Contract #: 04-0120F4Cty: SF/ALA Rte: 80 PM: 13.2/13.9File #: 69.25B**QUALITY ASSURANCE -- NON-CONFORMANCE REPORT****Location:** Changxing Island, Shanghai, P.R. China**Report No:** NCR-000613**Prime Contractor:** American Bridge/Fluor Enterprises, a JV**Date:** 07-Jan-2010**Submitting Contractor:** Zhenhua Port Machinery Company, Ltd (ZPMC), Changxing Island**NCR #:** ZPMC-0586**Type of problem:**

Reference Description: Base Metal Repair without Engineer approval located at West Tower Lift 4**Description of Non-Conformance:**

Subject: NCR No. ZPMC-0586

No. T-154

Draft of welding discontinuity:

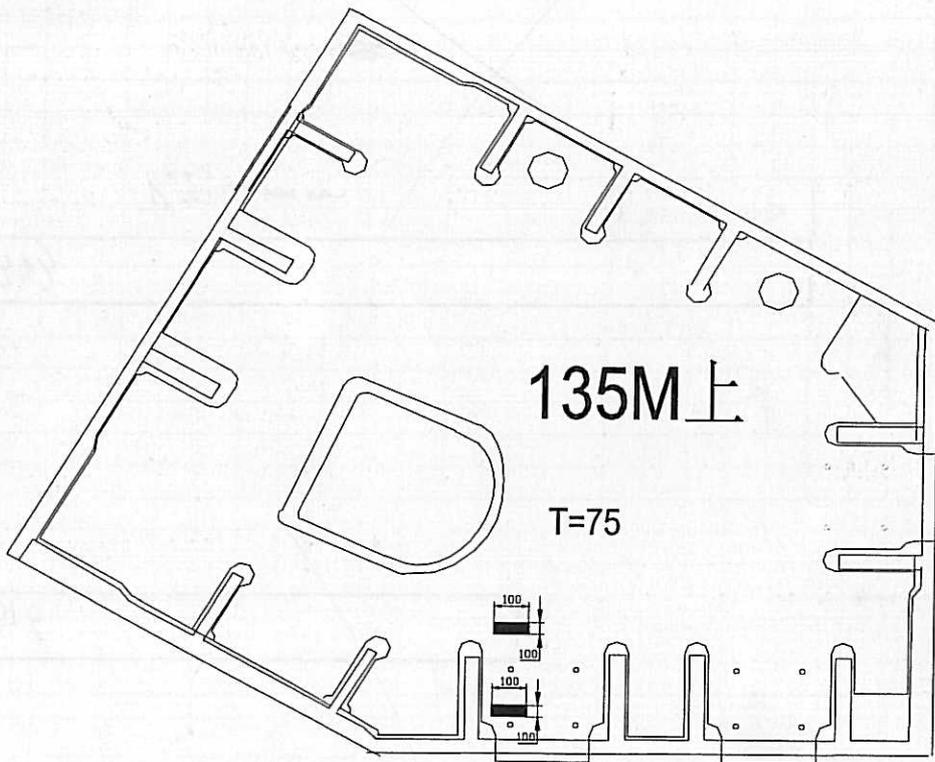
西塔四吊135M上层隔板定位块在焊接结束后，割除卡玛割损母材，深度3MM，长100MM。具体如图：

After welding west tower fourth lifting 135m top diaphragm fit plate, the base metal was gouged after removing temporary attachment, 3mm in depth, 100mm in length, the detail sees the following draft.

注：阴影处为需要补焊区域。Remark: repair area in shadow.

- 1、Grind the building-up area;
- 2、Preheat and weld passes temperature according to the approved WPS, it should be 2-3mm than the theory size;
- 3、Grind the weld area smoothly after repairing;
- 4、Check the welding according to the approved shop drawing.
